DOC16/237098-1
SSD 6693

Rye Park Wind Farm Response to Submissions (RTS) and Amended Environmental Impact Statement (EIS)

Rye Park Wind Farm Biodiversity Assessment Addendum (BAA)

Map 14A – turbine 22

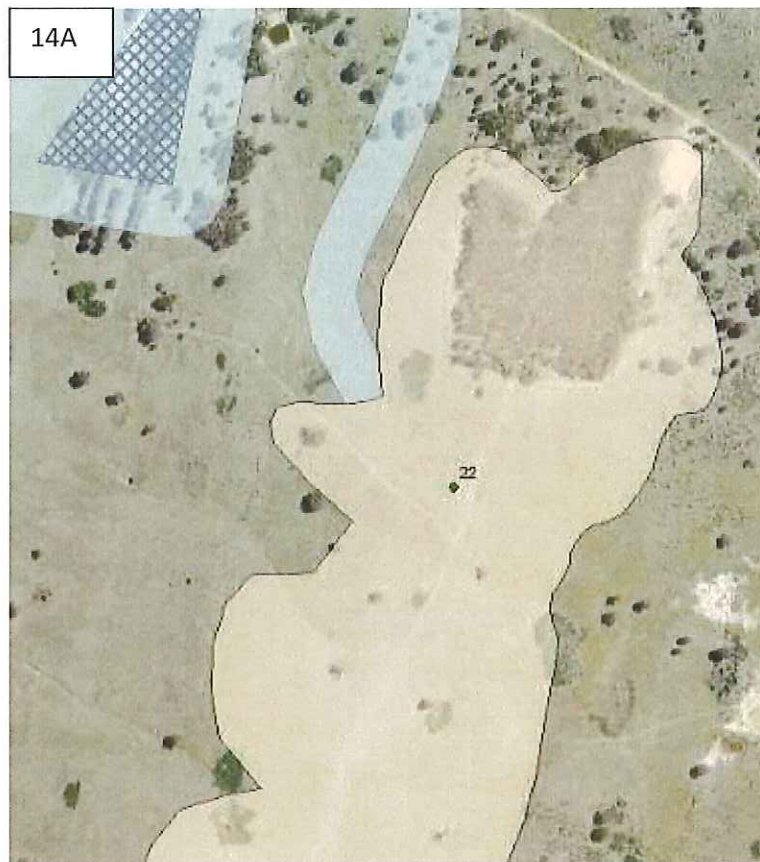
The intact forest remnant to the north of 22 should be excised from the micro-siting corridor

The patch of intact remnant Scribbly Gum forest should be excised from the southern end of this micro-siting corridor.

Access roads

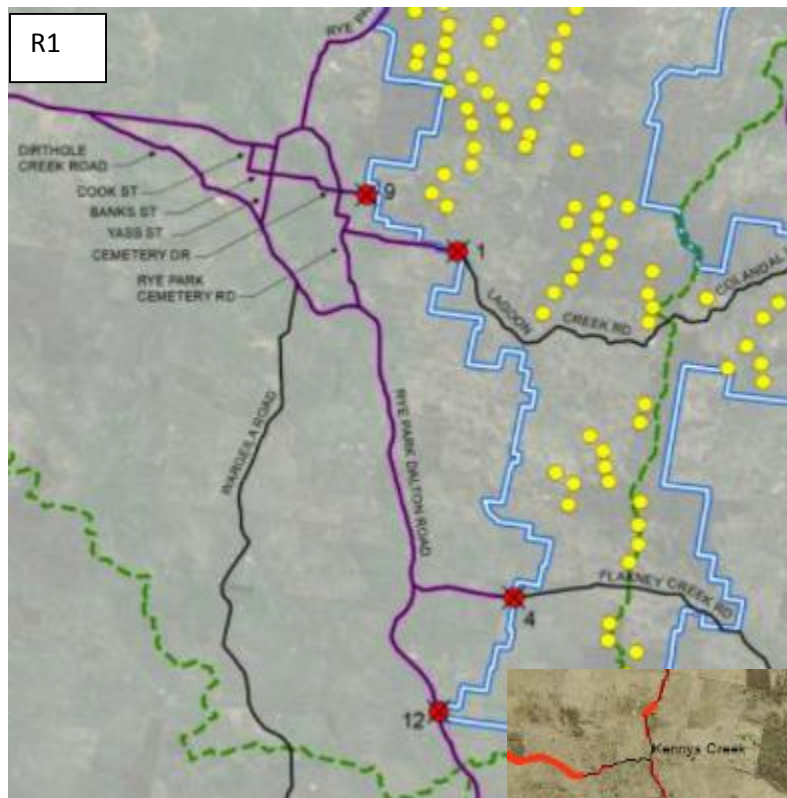
The site access map - fig 4-2 in Appendix E: Traffic and Transport Assessment (map R1, left) - shows that “overdimensional” vehicles will access the wind farm along the roads marked in purple.

OEH requests advice from DPE on the road width required for these vehicles.

BX3 – and the rest of Flakney Creek Rd.

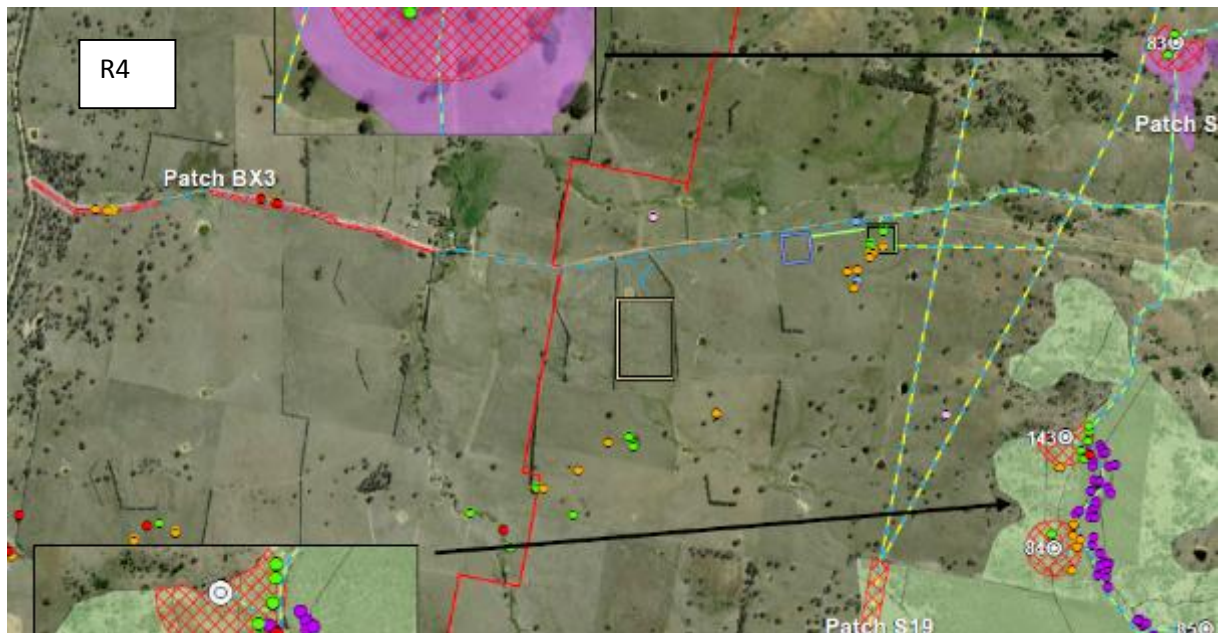
BX3 is roadside remnant vegetation containing mature trees, several HBTs and providing an important landscape linkage.

There are numerous threatened species records along Flakney Creek Rd, and two Superb Parrot nest trees in the vicinity which must be protected by a 100m buffer. Superb Parrot nest trees and buffers must be clearly marked on the ground and on maps to ensure they do not get damaged. All HBT to be removed in this area must be checked for threatened species before removal and removed outside of SP breeding season.

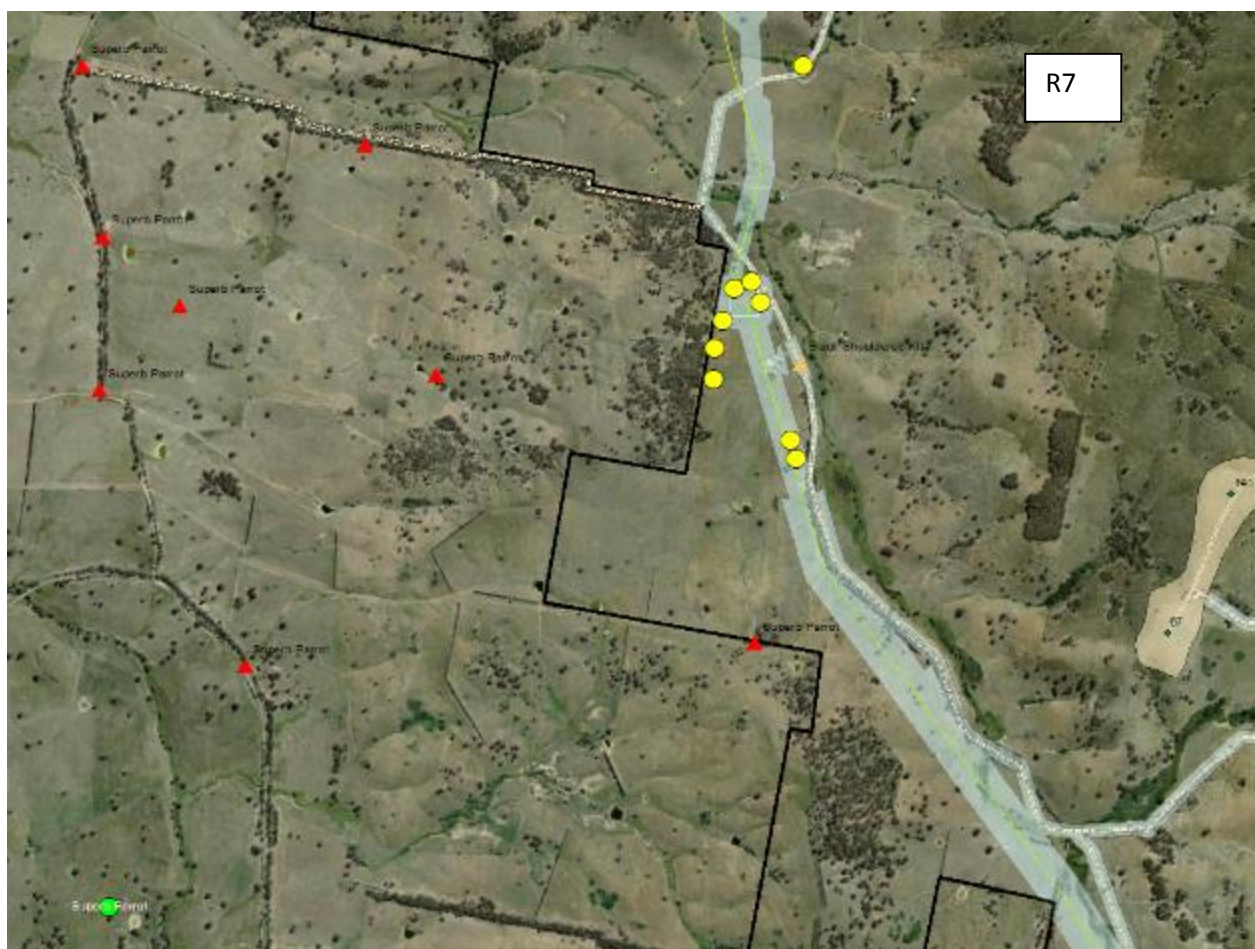
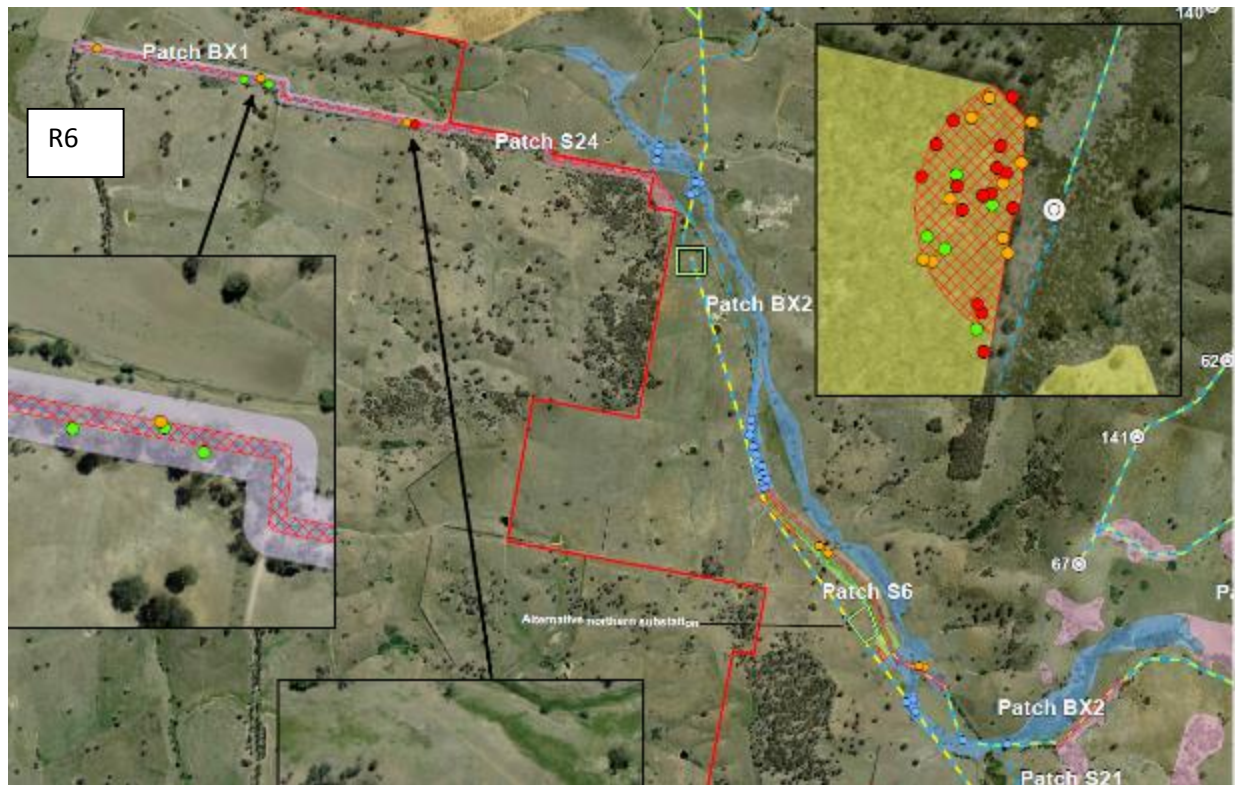
BX1 and BX2 (Box Gum Woodland) and S24 (Dry Forest). These roadside remnants contain large old HBTs and essential habitat for the threatened Superb Parrot, which breeds in hollows this area.

Patch S6

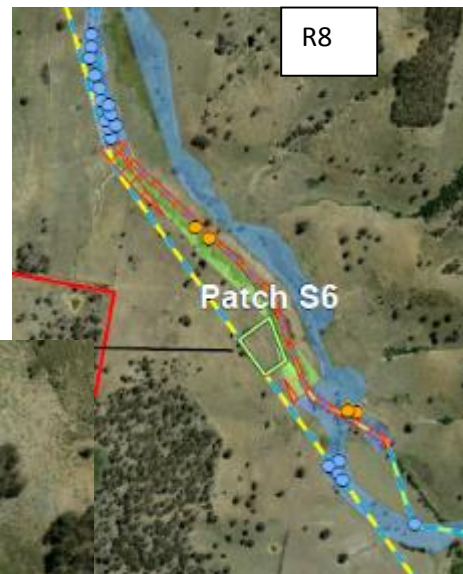
The patch S6 vegetation along High Rock Road should not be cleared as it is essential remnant habitat in this area, including HBTs. There is a large body of evidence validating the essential role of mature roadside vegetation in agricultural landscapes. The loss of this vegetation cannot be offset due to its unique connectivity value in situ.

The map R9 (left) illustrates a 15m road width as required for the transport of the large wind farm vehicles. This would be likely to remove the roadside vegetation.

OEH strongly recommends that this wind farm access road be realigned in this area so it does not follow High Rock Rd and therefore does not require the clearing of this vegetation. It should be relocated into cleared land.
